Central Place Sydney

Block B Response to Submissions

17 June 2020 |

Prepared by MG Planning Pty Ltd

Figure 1: Updated building envelope

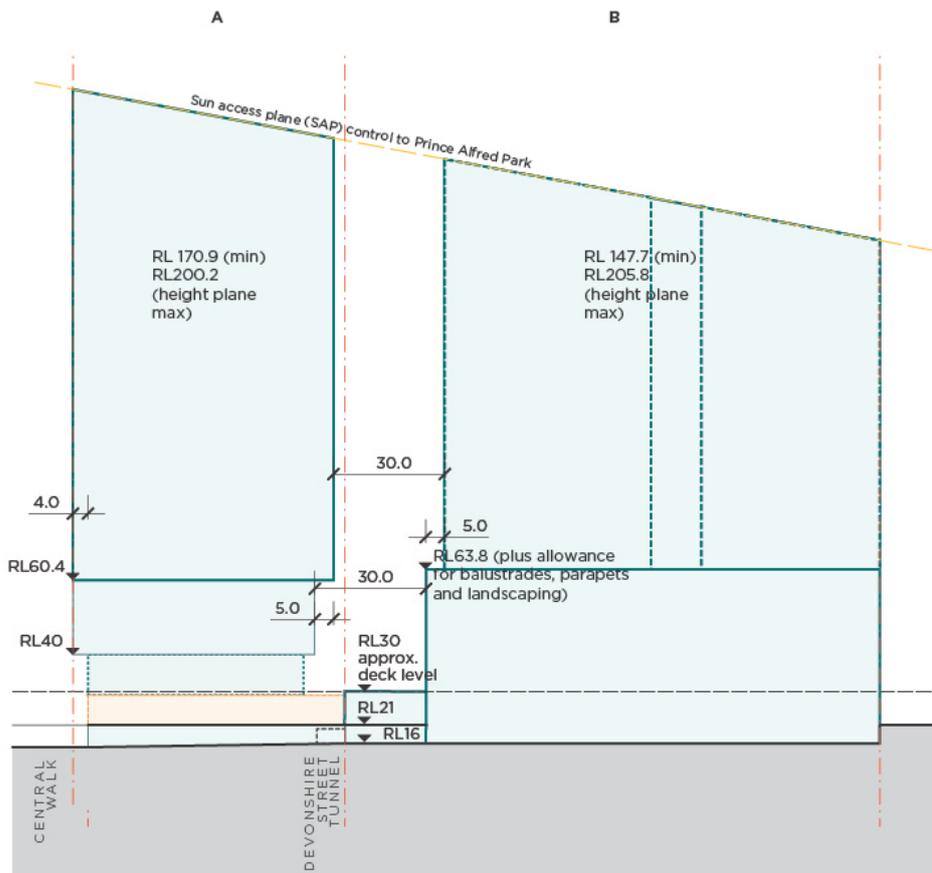
Stakeholder	Feedback / Recommendations
PRP	<ul style="list-style-type: none"> • Requirement for a minimum 30 metre clear separation between the planning envelopes of Block A and B. • Reliance on secondary/ancillary treatments to mitigate potential impacts arising from a narrower separation would not be supported. • Amendments to the Draft Design Guide be amended to require a minimum 6 metre setback above the podium along the Lee Street frontage to minimise negative wind impacts. (Note: it is understood that notwithstanding the City of Sydney Council’s recommendation for a 3 metre setback along Lee Street, the Council in fact supports the PRP’s position.)
City of Sydney Council	<ul style="list-style-type: none"> • Design controls in the Draft Design Guide be strengthened to achieve: <ul style="list-style-type: none"> ○ A minimum 30 metre separation between Blocks A and B ○ A minimum 3 metre setback above the podium along Lee Street and appropriate setbacks between tower elements to reduce bulk and scale ○ An 80% active building frontage requirement to maximise street and laneway activation ○ 75-80% envelope efficiencies to ensure building massing and envelopes provide flexibility for articulation and other design features.

Stakeholder	Feedback / Recommendations
PRP	<ul style="list-style-type: none"> • Reiteration that wind impacts need to be addressed at the rezoning stage through changes to the proposed building envelope massing.
City of Sydney Council	<ul style="list-style-type: none"> • Stronger guidance in the Draft Design Guide to ensure appropriate wind mitigation is built into building envelopes and to require wind mapping. • Recommended the wind map identify appropriate criteria at key points within the development and in all areas affected by the development. • Building separation distances and setbacks need to better address wind issues.

The Block B building envelope has been amended to:

- Provide for a 30 metre building separation between the tower forms on Blocks A and B
- Revise the podium height from RL63 as shown in the Draft Design Guide to RL63.8 (excluding balustrades and hand rails).
- Provide for a 6 metre setback above the podium on Lee Street, with the opportunity to consider reducing to 3 metres
- Include a Terrace Pavilion in the north-eastern corner of the site.

The proposed Block B building envelope incorporating the amendments is shown in the drawing below.
